Final Modification Report

CMP357: To improve the accuracy of the TNUoS Locational Onshore Security Factor for the RIIO2 Period

Overview: The TNUoS Locational Onshore Security Factor is required to be reviewed before the start of the next RIIO2 price control period in April 2021. The Proposer is seeking to improve the accuracy of Locational Onshore Security Factor by ensuring that it is applied using eight decimal places.

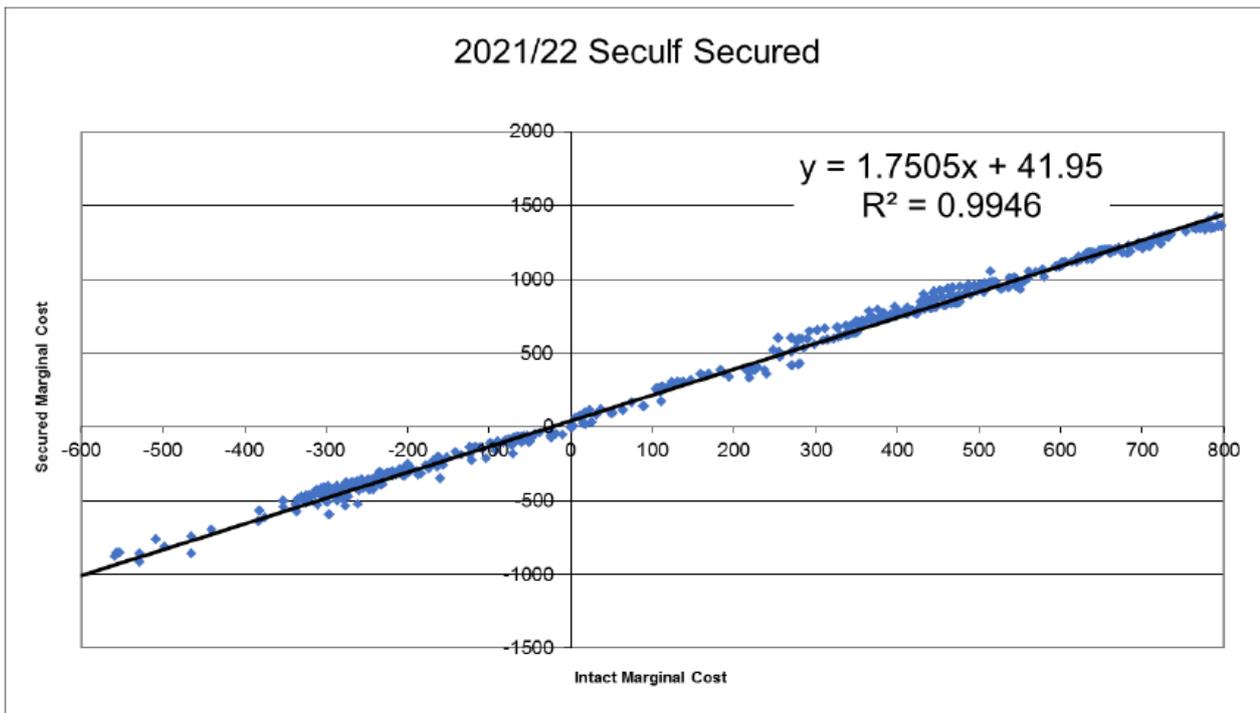
Workgroup Members questioned how many decimal places the calculation behind these tables were calculated to. One Workgroup member suggested that it could be up to 13

decimal places. The Workgroup was advised that most input data into the tariff model was more granular than 8 decimal places.

The Workgroup agreed that the plot of the data shows high precision, as the dots were placed close to the line and the R squared value was high, but this did not mean the line itself may be accurate. One Workgroup Member questioned why the regression was run to calculate an intercept and gradient when only the gradient was used in the Locational Onshore Security Factor, meaning that an intercept of zero was effectively used. The workgroup member asked whether a regression could be run again with an intercept of zero, as this could possibly give a more accurate value for the Locational Onshore Security Factor. This analysis is provided in Annex 7c. Two respondents to the Workgroup consultation highlighted that there were potential errors with the current calculation of the Locational Onshore Security Factor due to it being derived through a regression which calculates a gradient and intercept value, when only the gradient is used when the Locational Onshore Security Factor is applied to tariffs. The respondents believed that the gradient calculated with the intercept set to zero (the line going through the origin) would be more appropriate as it is more consistent with how it is applied. This was supported by some Workgroup Members who noted that the ESO analysis showed a strong correlation for this regression with an average R squared value of 99.0%, which compared well with the 99.4% achieved for the original regression. These Workgroup Members also noted that the factor calculated by this regression would take the value of 1.80 when expressed to two decimal places.
